DETAILED RESULTS FROM ONLINE SURVEY

TWO FEASIBILITY STUDIES OF REGIONAL TRAIL LINKAGE TO THE COMMUNITY PATH EXTENSION (CPX)

FEASIBILITY STUDY A:

COMMUNITY PATH EXTENSION: CONNECTION TO THE GRAND JUNCTION PATH

Q12: Of the 3 route options that connext the CPX with the GJP shown above, please rank your prefernces from 1 to 3, with 1 being your most preferred. (You can view the three options in more detail in the following map graphics)

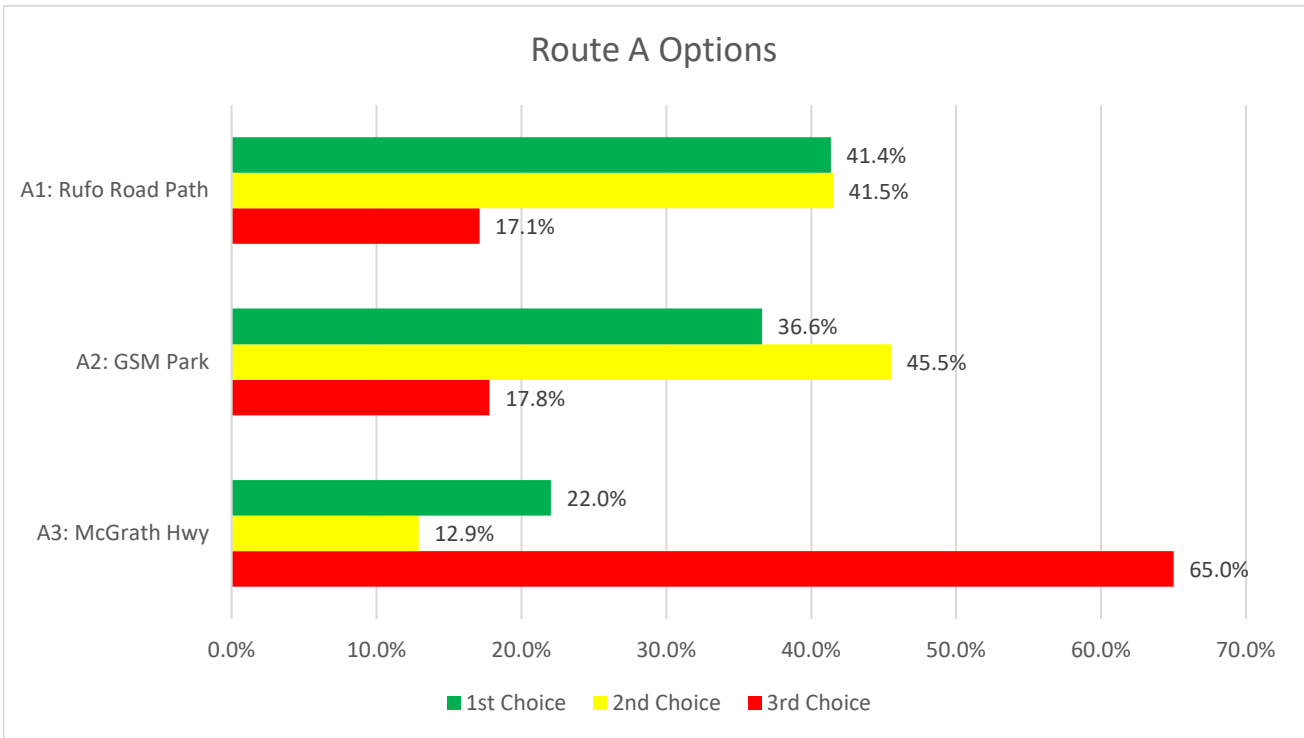
| # | RESPONSES | DATE |
|----|--|--------------------|
| 1 | The connections must be as simple, continuous, and safe as possible. Switching between conditions (for example, when a fully off-road path switches to a buffered on-street bike lane), reduces both the safety and utility of a route. Any condition that crosses a large road (ie the proposed ramp to cross McGrath) needs further explanation and scrutiny. | 4/20/2020 12:07 PM |
| 4 | I think the expected level of bike traffic (while great) will be too much to route on the shared path along Gore St, because it's actually a sidewalk as well as a multi-use path combined. There are poor sight lines on the side streets along Gore, and 170 Gore and the Cambridge Housing at Lambert and Gore both have a high proportion of older folks. I say this as somebody who fought hard to get the path along Gore, I think it would create problems. Similarly, I really think it would be way too much bike traffic to route through the Gold Star Mother's Park. I like the idea of providing bike traffic a faster, less congested path through the park/parking lot in A3, but why can't it just take advantage of the Somerbridge connection like A1? | 4/20/2020 1:17 AM |
| 10 | It seems like option 3A should be a second level goal, with a connection to bring people heading north from the Grand Junx path (shortest route if you are heading that way) but for this project, goal should be best way to get to the other existing (or in dev'p) paths. | 4/19/2020 9:42 PM |
| 13 | i think options 1 and 2 are both good. But at least we know the owner of the forthcoming Somerbridge hotel is amenable to that connection; the future of Sav-Mor property is unknown. | 4/19/2020 8:38 PM |
| 14 | How would you prevent cyclists from taking a shortcut through the parking lot in option 3? | 4/19/2020 7:20 PM |
| 17 | A3 seems like no one would ever want to go that way and the likely hood of that area ever changing is close to zero. | 4/19/2020 6:06 PM |
| 18 | A3 seems to be a large detour. | 4/19/2020 4:45 PM |
| 21 | A3 looks pretty unpleasant, I believe the service roads have high truck traffic | 4/19/2020 1:19 PM |
| 22 | For A3, I'm skeptical that sharing space with service vehicles behind the commercial areas would work well. The interactions I've had with delivery drivers while on my bike makes me believe that they are primarily concerned with completing their jobs on schedule, and not with how they may inconvenience others with their driving/parking, so I think this would end up being frustrating for all users. I like option 1 the best, but I am quite comfortable around car traffic - | 4/18/2020 3:31 PM |

| 23 | Combine A2 & A3: use the ramp from path in A2, then from A3 use the route of rail tracks and then behind the Twin City plaza with a separated 2-way path to provide a more direct and seamless travel ability on the path to the GJP for bicyclists. This will keep the most separation between bikes and cars, especially on the busy MSOB hiway. | 4/18/2020 1:44 PM |
| 24 | A1 makes so much sense to connect to star market. It seems like a no-brainer to me. | 4/18/2020 12:18 PM |
| 25 | A2 option is unacceptable. Love the idea of making a connection to the park but creating a path through the park will have negative impact on park. Option 1 connects to the park without bringing in fast-riding cyclists to cut off connection between tot lot and field. This will only serve out of community cyclists utilizing path as cut through. Please do not destroy this park with this option. This will divide supporters. | 4/18/2020 11:58 AM |
| 26 | A2 seems to be the most direct and enjoyable (due to the section through the park) | 4/18/2020 8:47 AM |
| 27 | Why not combine options A3 and either A1/A2: continue the GJP along the tracks up to where Rufo Rd and Route 28 intersect (following A3), then cross Route 28 and proceed to the CPX (following A1 or A2 routes). This would virtually eliminate riding on paths along the street. It would be 100% off-street to go from GJP to CPX and still minimize the detour. | 4/17/2020 8:40 PM |
| 30 | My assumption is that A2 (my preferred option) goes over McGrath hwy instead of at-grade crossing requiring waiting for traffic signals. I made A3 my least favorite because it is a long, winding route to connect paths. | 4/17/2020 12:41 PM |
| 32 | The path next to 28 in A3 sounds miserable, even if it's separated with concrete barriers (no flex posts there please, that road is too fast!), plus it's longer. | 4/17/2020 9:22 AM |
| 35 | All three would be vast improvements over the status quo, but A1 and A2 also improve pedestrian access across McGrath (e.g, for people catching buses on the far side from the shopping district). | 4/16/2020 10:57 PM |
| 37 | 1) It seems like a tremendous waste to have the proposed extension run parallel to the under construction path for considerable distance (A3). 2) Path A2 seems like a fine option provided that left into the park is safe and the path doesn't impact safety of those in the park. | 4/16/2020 6:18 PM |

Q16: Of the 3 route options that connect the CPX with the MRG shown above, please rank your preferences from 1 to 3, with 1 being your most preferred. (You can view the three options in more detail in the map graphics below)

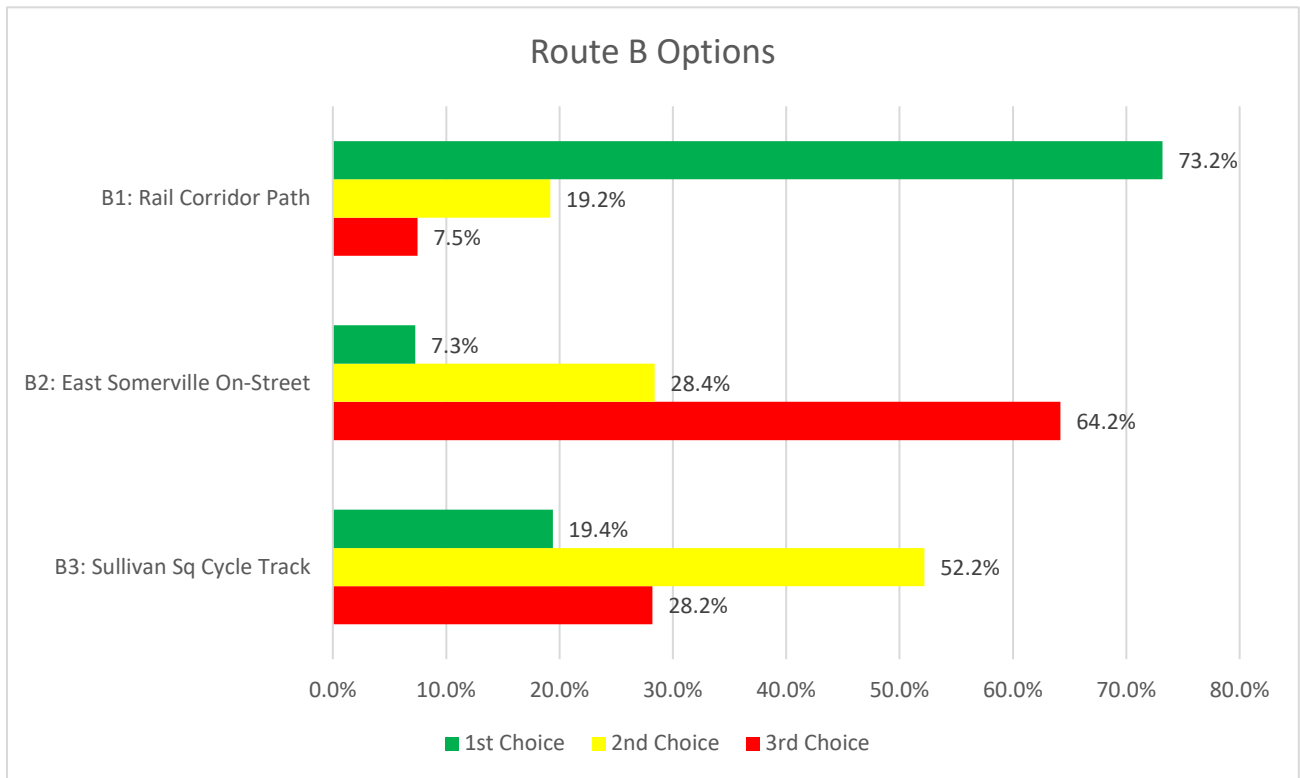
| 85 | It's critical to provide a direct connection to Sullivan Square. Additionally, it will be difficult to encourage less-experienced cyclists to use the new facilities if they're primarily on-street lanes. | 4/11/2020 4:08 PM |
| 87 | The B2 surface options around Sullivan are a bit of a mess. I would love to have the grade-separated B1 "bypass". B3 local street contraflow lanes would be helpful but not much value-added and hilly. Long-term, a direct connection of rail grade to Inner Belt road south to Lechmere would be awesome if we could find the \$\$. | 4/11/2020 2:04 PM |

| 91 | Using Inner Belt to provide a direct line from assembly to cambridge would be absolutely transformational. Providing the bridges to turn the dead end into connections to Cambridge would unlock tremendous value for that under-utilized area between Assembly and Inman. The costs would be a very wise investment in the long-term as Kendall Sq forces rents, especially for commercial lab space, out of the orbit of smaller biotechs that value proximity to hospitals and universities but have been forced to the far suburbs | 4/11/2020 11:52 AM |
| 105 | Working in the Inner Belt area and a resident of East Somerville and formerly East Cambridge over the last 3+ years (as a walking commuter), plan B3 is exactly what I would have asked for to connect the two areas (especially with the incoming green line extension) | 4/10/2020 1:08 PM |

| 107 | Regardless of which path is chosen, it should include the overpass/link between the CPX and Inner Belt. That doesn't necessarily have to be linked to the path plan for B3. | 4/10/2020 1:00 PM |
| 114 | You don't provide data on elevation changes. Are Mt Vernon & Mt Pleasant not mounts, and would their be greater winter impacts due to snow/ice, whereas B1 & B3 are level? | 4/10/2020 10:17 AM |

| 127 | B1 with B3's Inner Belt section added would be even better. | 4/9/2020 2:20 PM |

| # | RESPONSES | DATE |
|----|---|--------------------|
| 21 | clarify why B2 is set up the way it is (ie, is it due to existing patterns of one-way street traffic, to save parking space for residents/retail, etc) | 4/16/2020 10:34 AM |

| 79 | B3 is difficult to understand, and I'm a planner! | 4/10/2020 4:45 PM |
